RESPONSE TO REQUEST FOR ADDITIONAL INFORMATION

APR1400 Design Certification

Docket No. 52-046

RAI No.: 256-8321
SRP Section: 09.02.02 - Reactor Auxiliary Cooling Water Systems
Application Section: 9.2.2
Date of RAI Issue: 10/19/2015

Figure 9.2.2-1 Component Cooling Water System Flow Diagram (Sheet 1 of 4)

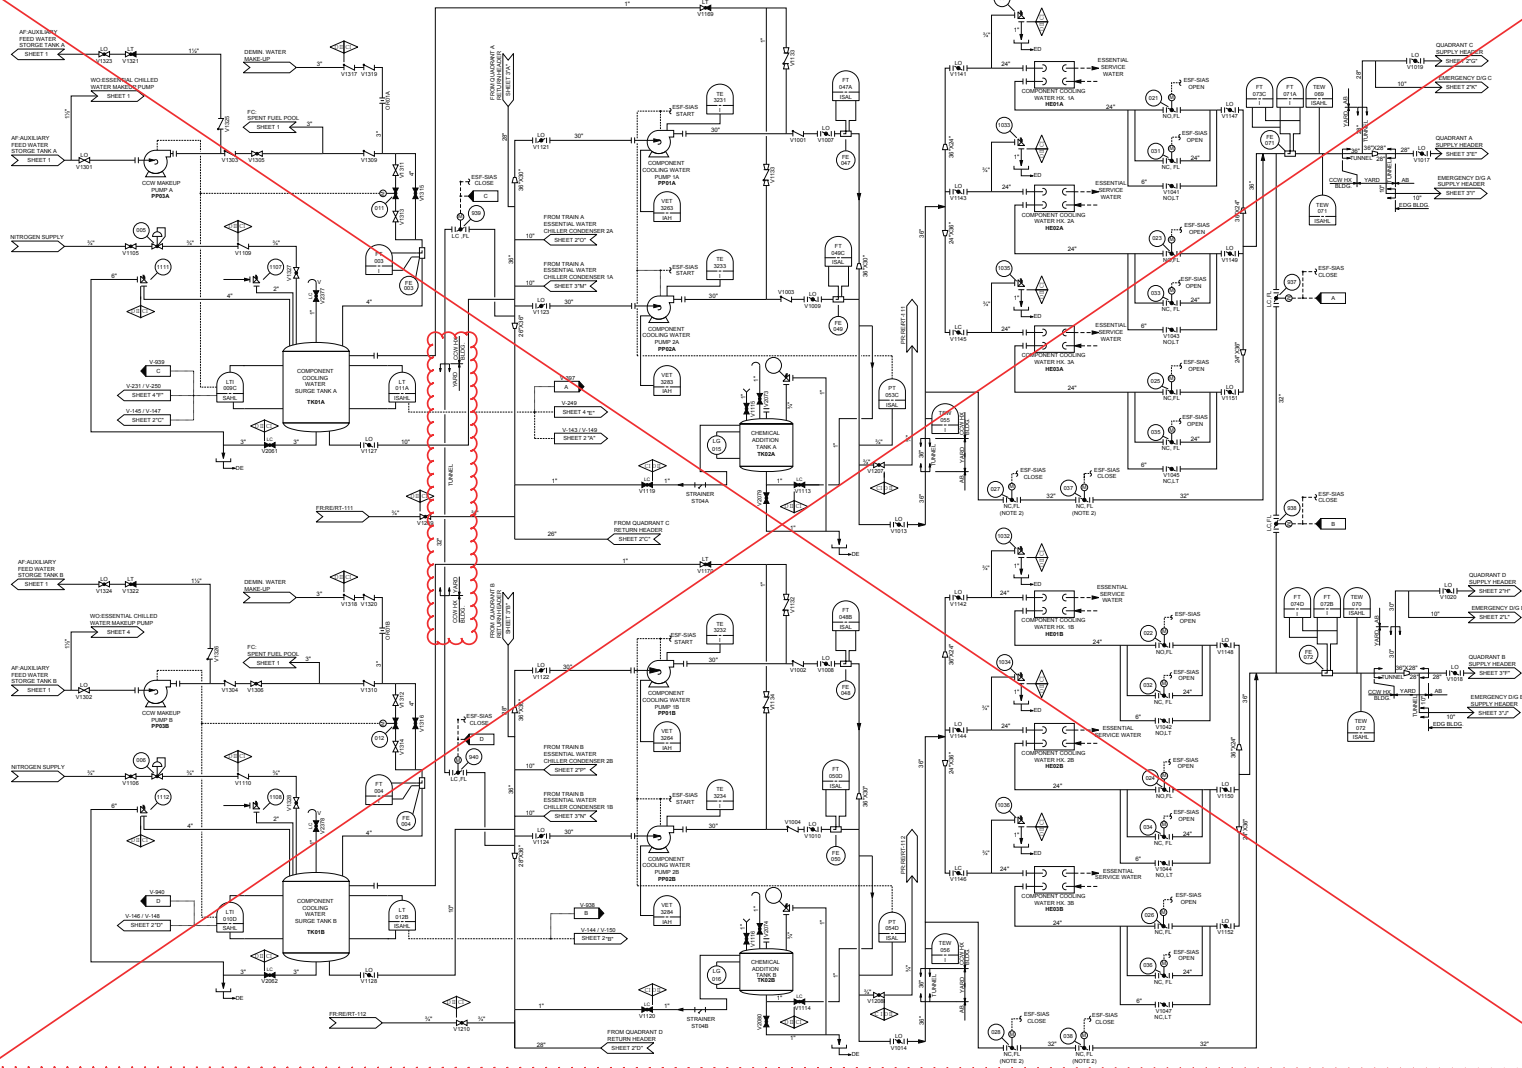
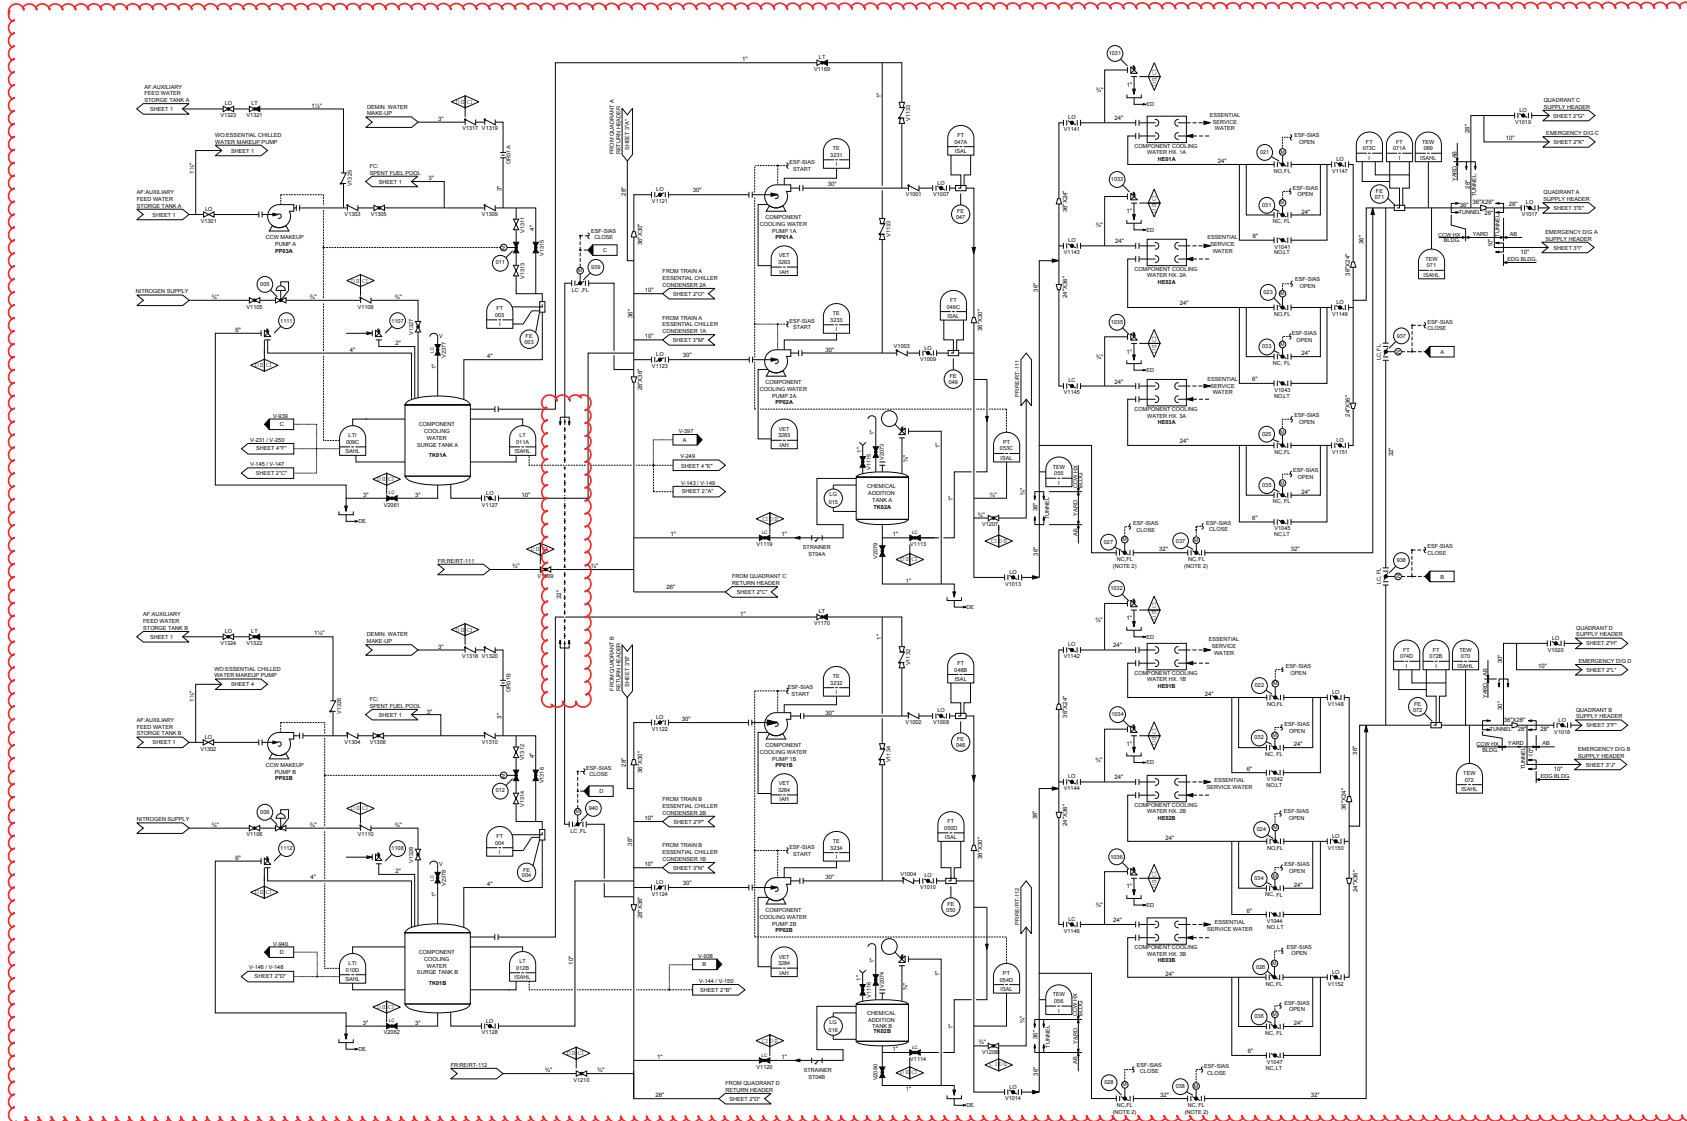
Based on a review of the general arrangement drawings in Chapter 1 of the DCD, and the component cooling water flow diagram in Section 9.2 of the DCD, it appears that there are CCWS SSCs housed in tunnels connecting the CCW equipment in the Auxiliary Building to components in other buildings like the EDG and CCW heat exchanger buildings. The staff is unable to verify that the SSCs in piping tunnels will be adequately protected against external environmental hazard since DCD Figure 1.2-1 does not identify the pipe tunnels to be in scope of the DCD, and protection of the CCWS SSCs inside the pipe tunnel is not discussed in the DCD. Therefore, the applicant is requested to:

- a. Identify pipe tunnels or any other features used to provide connection between CCWS SSCs in buildings that are physically separated from one another, and specify whether the tunnel/structure used is in scope of the DCD.
- b. Discuss how the requirements of GDC 2 are met in regards to the capability of the tunnels/structure housing the CCWS SSCs to withstand the effects of natural phenomena like earthquakes, tornadoes, hurricanes, and floods.

- d. In addition, Tier 1 Table 2.7.2.2-1 and Tier 2 Table 3.2-1 will be revised to correct the location of the CCW piping and valves. Figure 9.2.2-1, CCWS flow diagram, will be revised to indicate correctly the piping location of the CCW pump suction (Sheet No. 1/4) and the connection between the Auxiliary Building and Compound Building (Sheet No. 4/4), which are located in the Auxiliary Building, not in the piping tunnel outside of the plant building.

Replace with A in the next page
